POST-DEVELOPMENT WATERSHED MAP
HIGHLAND AT HOPKINS HILL, PHASES 1G,1H,1I,1J,1M,1N

Appendix F Contech Jellyfish Certification and Design Summaries

**RE: Highlands at Hopkins Hill (Contech Reference No. 831,512)
Review of Jellyfish Filter Design**

JELLYFISH JFPD0406
STANDARD DETAIL
PEAK DIVERSION CONFIGURATION

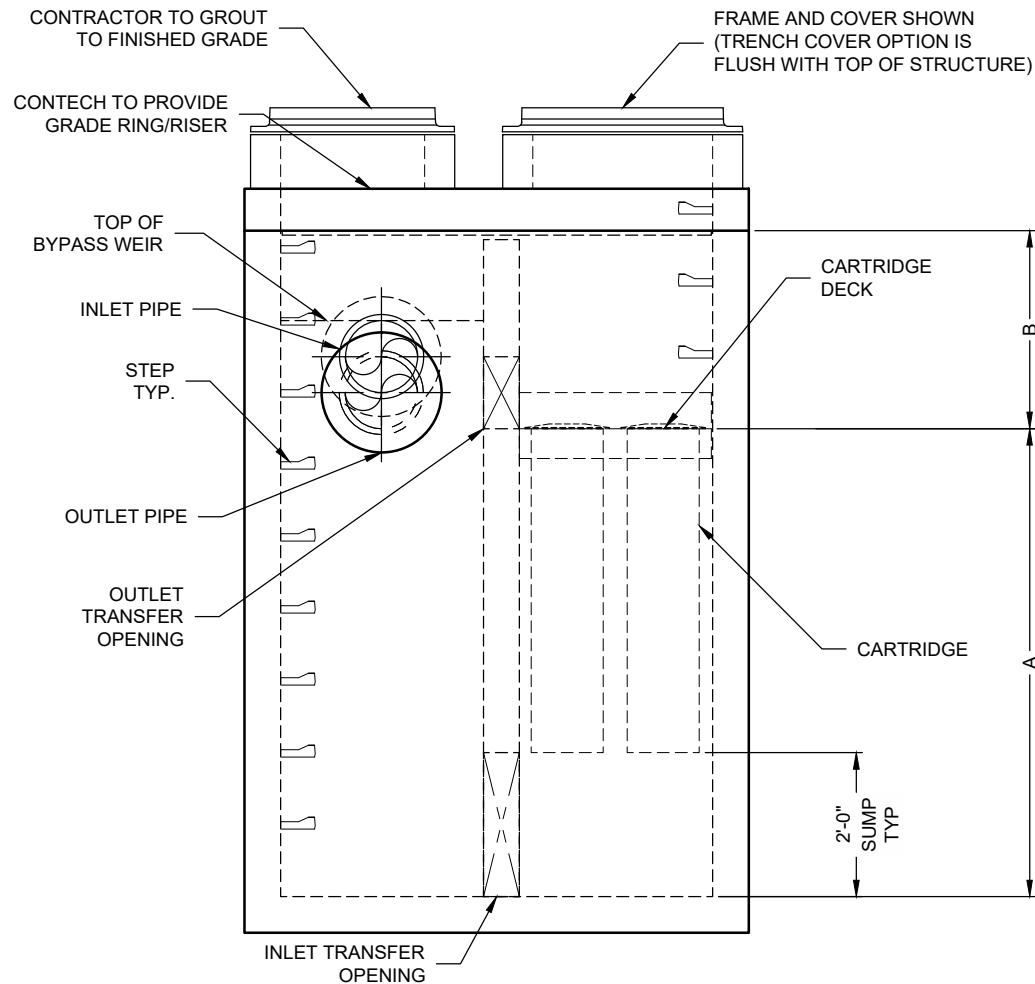
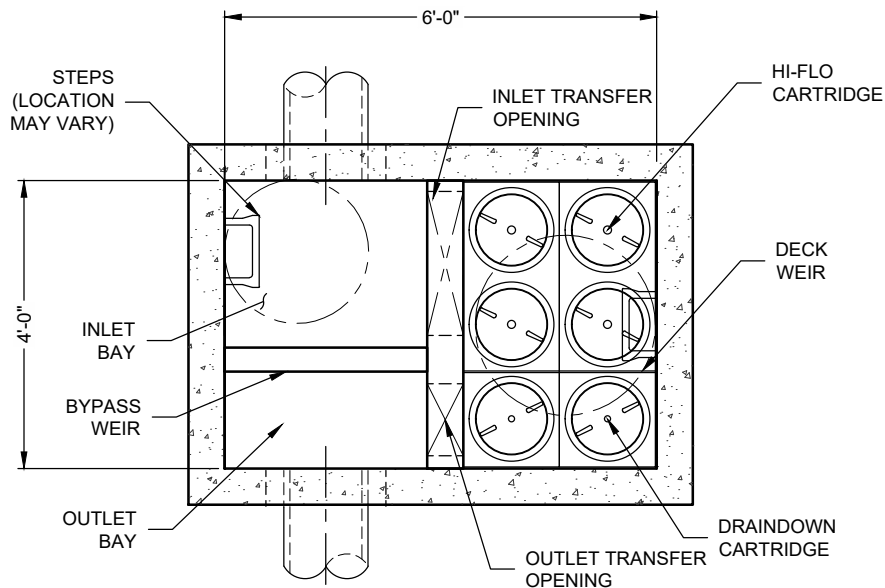
JF5

The engineer of record reports a drainage area of 0.671 acres (impervious) and a water quality flow rate of 0.59 cfs. The Jellyfish is designed in accordance with the tested hydraulic loading rate of the 40-inch cartridges at a maximum rate of 60 gpm with the inclusion of one draindown cartridge at a maximum rate of 30 gpm. To adequately treat the runoff from this area, Contech recommends a Jellyfish model JFPD0406-4-1 (40" cartridge length) with a treatment flow rate of 0.60 cfs.

JELLYFISH JFPD0806
STANDARD DETAIL
PEAK DIVERSION CONFIGURATION

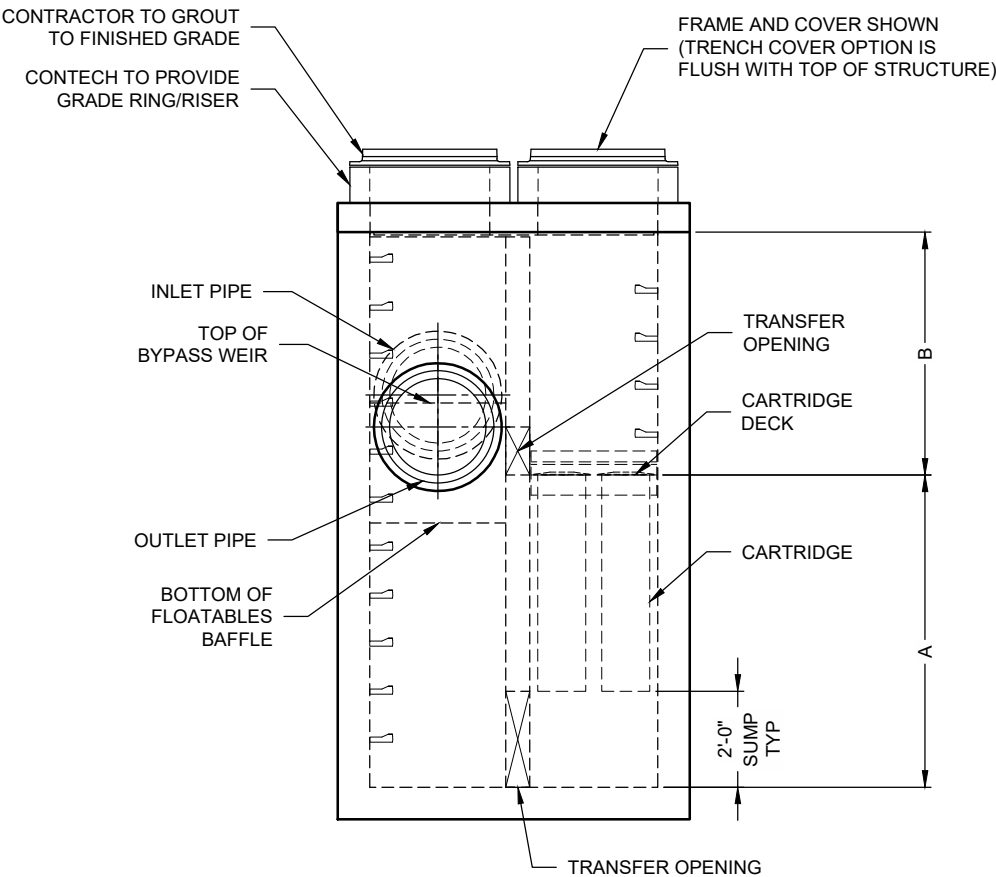
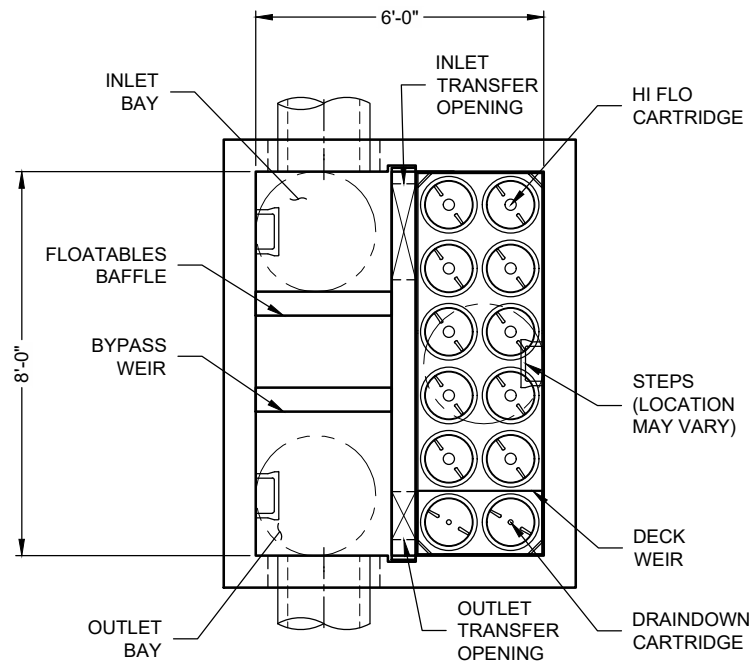
JF5A

The engineer of record reports a drainage area of 1.783 acres (impervious) and a water quality flow rate of 1.25 cfs. The Jellyfish is designed in accordance with the tested hydraulic loading rate of the 40-inch cartridges at a maximum rate of 60 gpm with the inclusion of one draindown cartridge at a maximum rate of 30 gpm. To adequately treat the runoff from this area, Contech recommends a Jellyfish model JFPD00806-9-2 (40" cartridge length) with a treatment flow rate of 1.34 cfs.

JELLYFISH JFPD0806
STANDARD DETAIL
PEAK DIVERSION CONFIGURATION

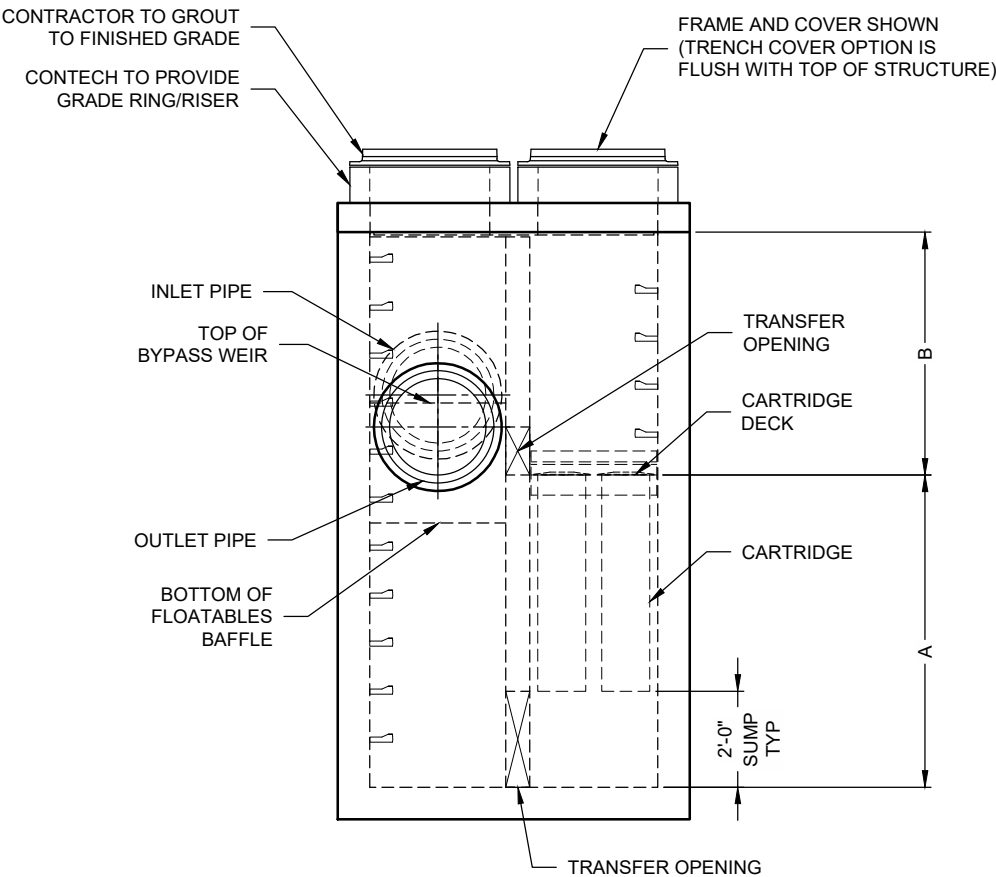
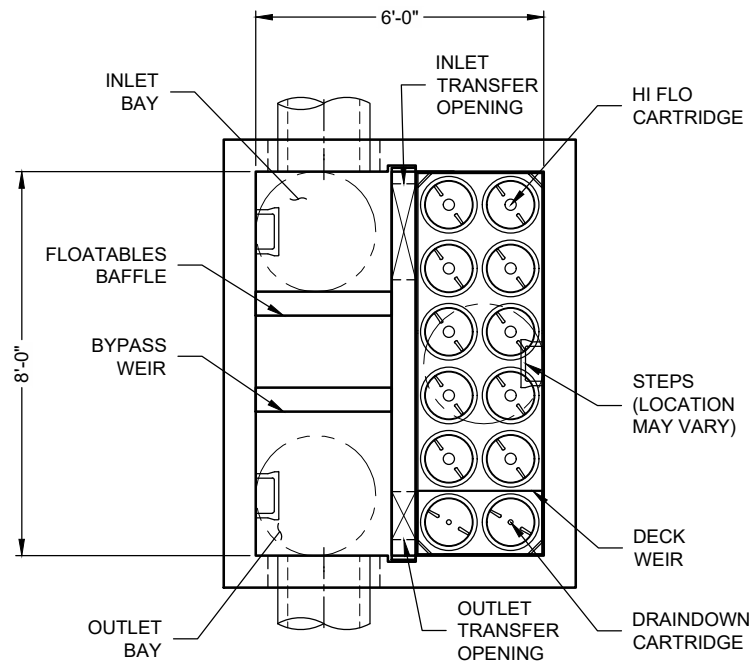
JF11

The engineer of record reports a drainage area of 1.211 acres (impervious) and a water quality flow rate of 0.85 cfs. The Jellyfish is designed in accordance with the tested hydraulic loading rate of the 40-inch cartridges at a maximum rate of 60 gpm with the inclusion of one draindown cartridge at a maximum rate of 30 gpm. To adequately treat the runoff from this area, Contech recommends a Jellyfish model JFPD00806-6-2 (40" cartridge length) with a treatment flow rate of 0.94 cfs.

JELLYFISH JFPD0406
STANDARD DETAIL
PEAK DIVERSION CONFIGURATION

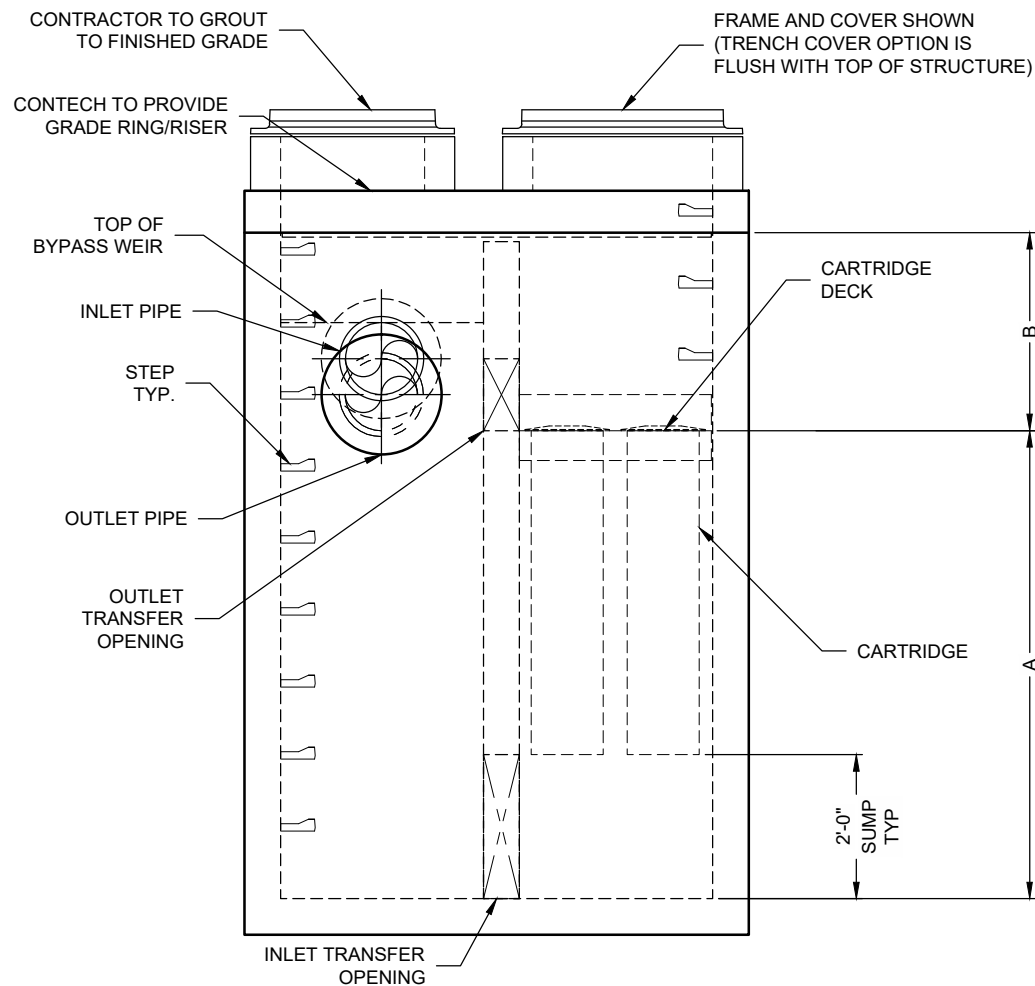
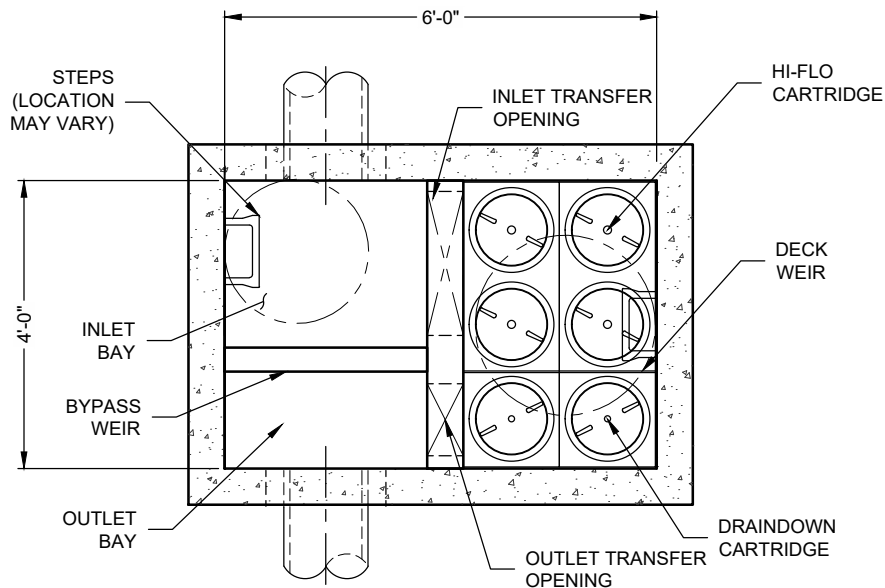
JF12

The engineer of record reports a drainage area of 0.647 acres (impervious) and a water quality flow rate of 0.53 cfs. The Jellyfish is designed in accordance with the tested hydraulic loading rate of the 40-inch cartridges at a maximum rate of 60 gpm with the inclusion of one draindown cartridge at a maximum rate of 30 gpm. To adequately treat the runoff from this area, Contech recommends a Jellyfish model JFPD0406-4-1 (40" cartridge length) with a treatment flow rate of 0.60 cfs.

JELLYFISH JFPD0806
STANDARD DETAIL
PEAK DIVERSION CONFIGURATION

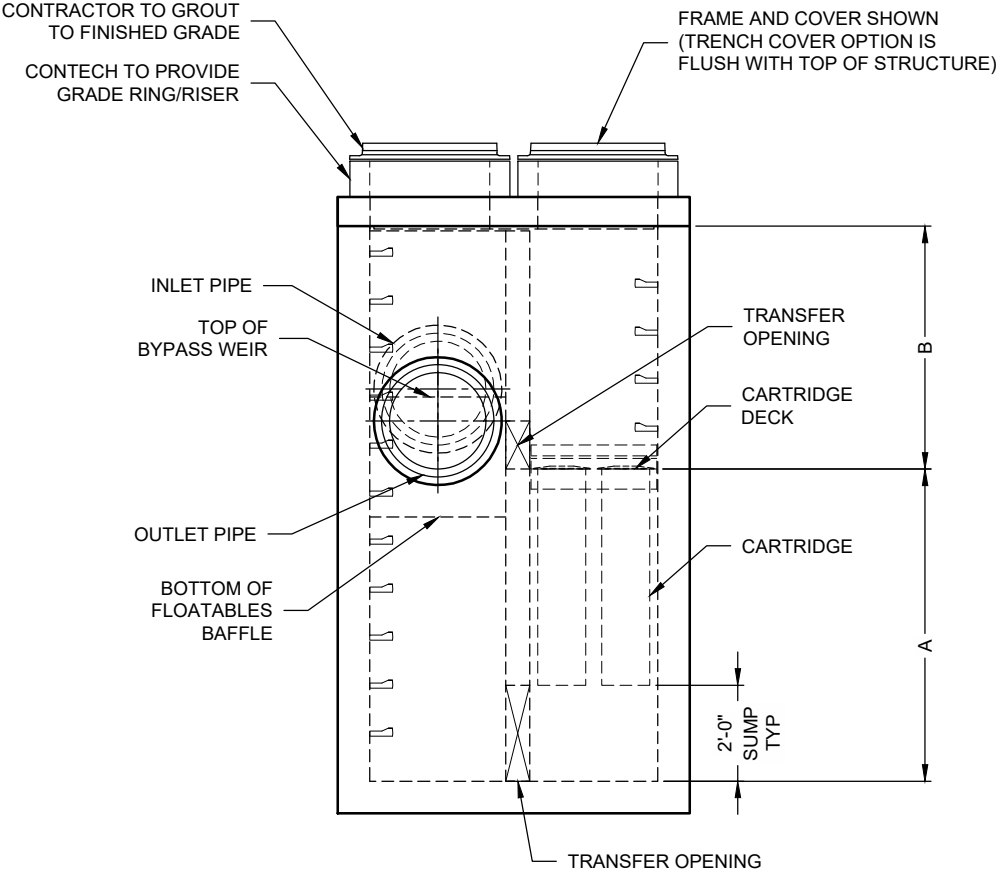
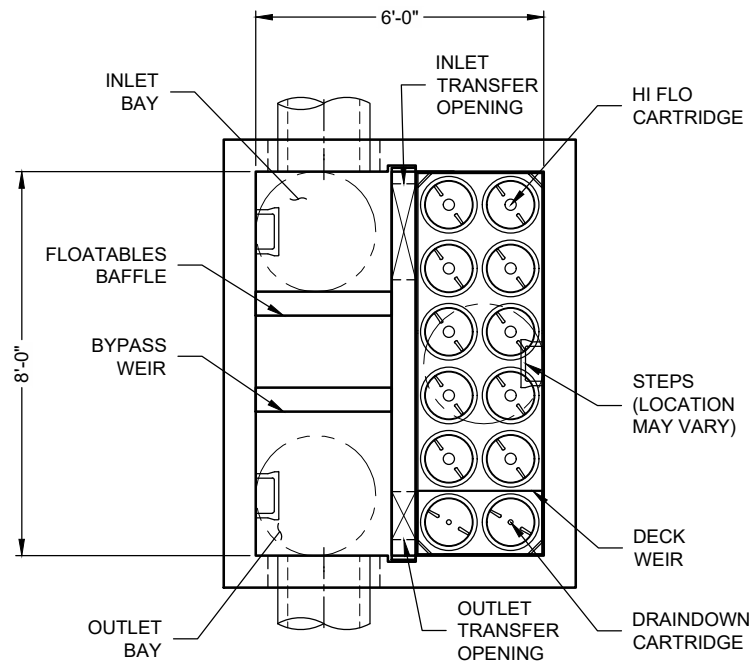
JF7

The engineer of record reports a drainage area of 0.879 acres (impervious) and a water quality flow rate of 0.96 cfs. The Jellyfish is designed in accordance with the tested hydraulic loading rate of the 40-inch cartridges at a maximum rate of 60 gpm with the inclusion of one draindown cartridge at a maximum rate of 30 gpm. To adequately treat the runoff from this area, Contech recommends a Jellyfish model JFPD00806-7-2 (40" cartridge length) with a treatment flow rate of 1.07 cfs.
